CONSTRUCTION SUMMARY
EARLGLEN INVESTMENTS INC.

LOT NUMBER	PHASE	HOUSE TYPE	CLOSING DATE	
057 BLOCK 009	1	THE CHARLOTTE-ELEV B-STD MAIN-3 BDRM-3 BATHS	01-Apr-26

This Document is Extremely Time Sensitive - Printed 17 Jun 25 at 11:17

* INTERIOR COLOUR SCHEME *

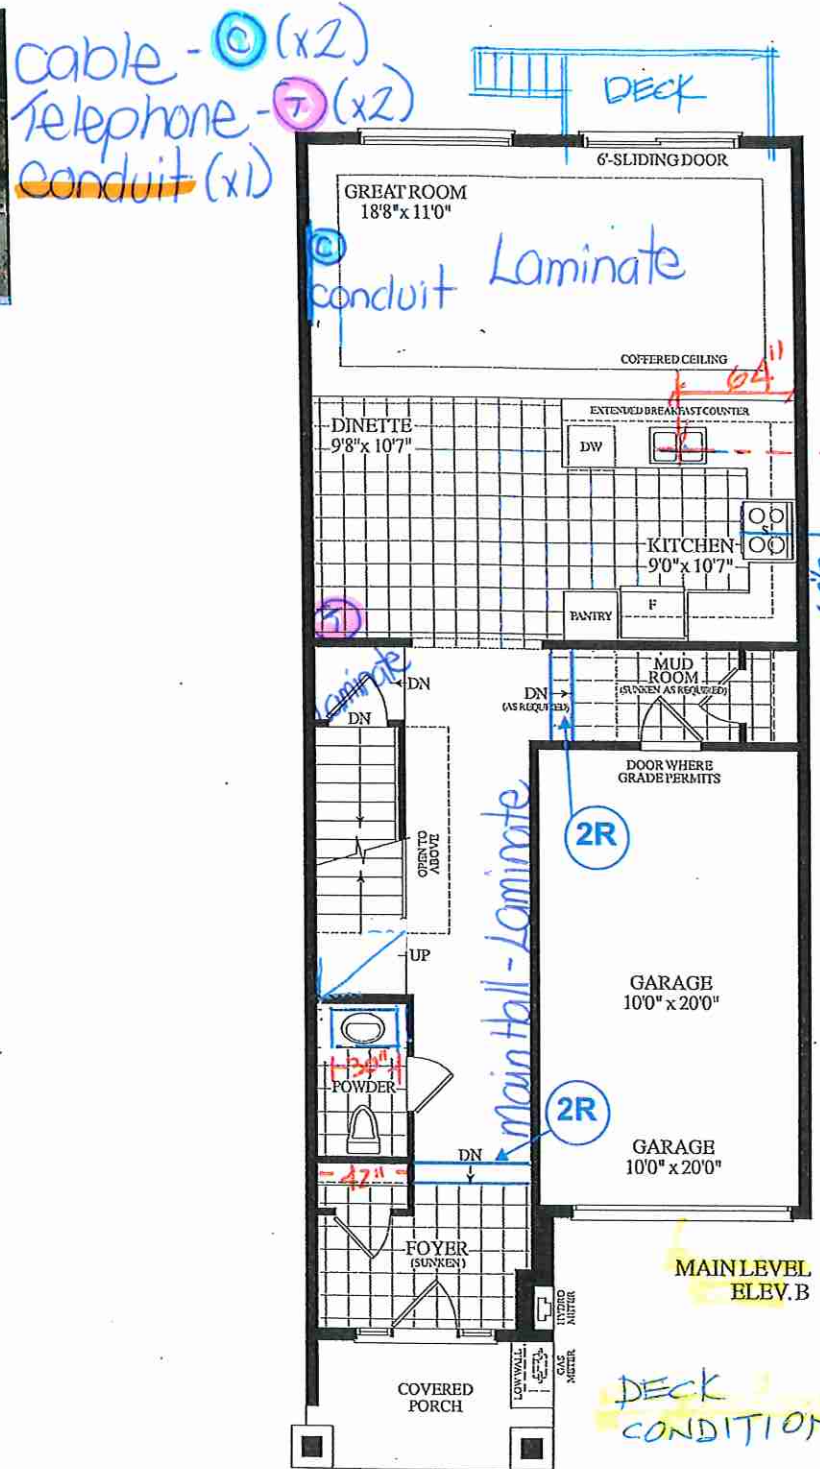
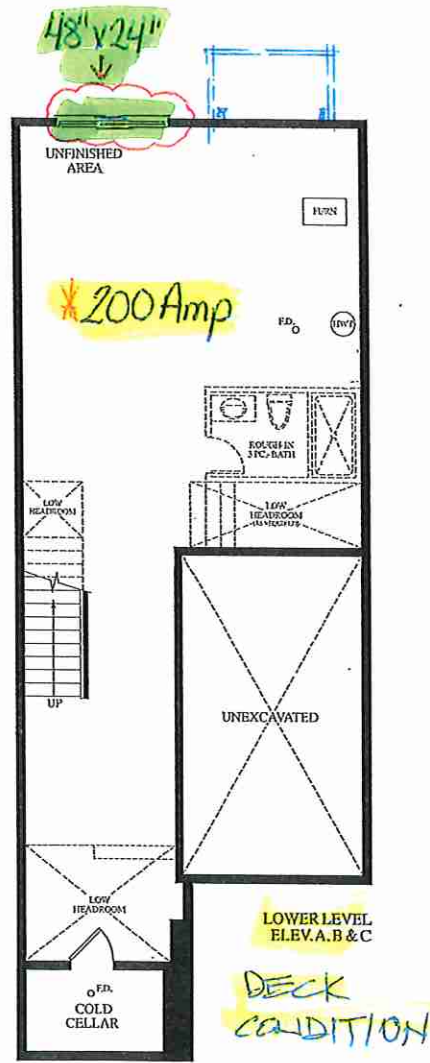
1 - Install Builders Standard Cable Rough-Ins (x2) and Install Builders Standard Telephone Rough-Ins (x2) (See Sketch) Note:
1 - STAIRCASE VS FLOORING WOOD SPECIES DIFFERENCE: STAIRCASE - The purchaser was advised and therefore accepts and acknowledges that the wood species of the staircase and flooring chosen do not match. This difference may result in a stain colour variance. Note: The purchaser agrees that the vendor is to be exempt from any and all claims by the purchaser regarding this colour variance.
1 - KITCHEN & BATHROOMS - Purchaser has DECLINED All Upgrades offered during decor appointment at the decor centre for kitchen & bathroom cabinetry. Standard Kitchen Layout & Standard Bathroom Vanities to be installed as per standard plan. (See Sketch) Note:
1 - APPLIANCES – INSTALL STANDARD APPLIANCE PACKAGE (See Attached) Note:
1 - KITCHEN - COUNTERTOP - Install Builders Standard Stone Countertop – EVEREST MAPLE WHITE with STANDARD " A " EDGE PROFILE - To be installed throughout kitchen, where applicable (does not include stone backsplash) (See Sketch) Note:

Handwritten notes: cable - (x2), telephone - (x2), conduit (x1)

ENSUITE ELEVATION

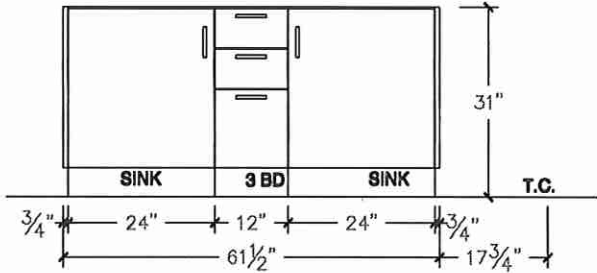
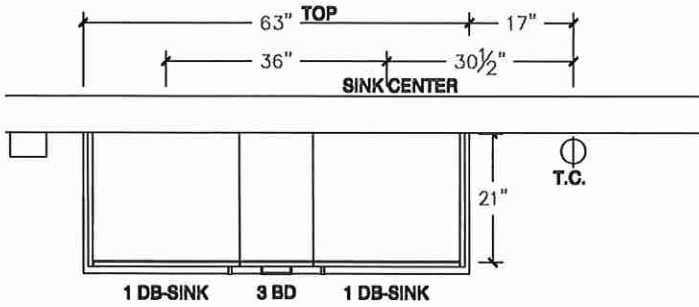
1 - CLARIFICATION;
PRIMARY ENSUITE - Purchaser Accepts & Acknowledges revisions made to primar ensuite vanity and toilet locations (As Per Fonzie C.) (See Sketch)
Note:
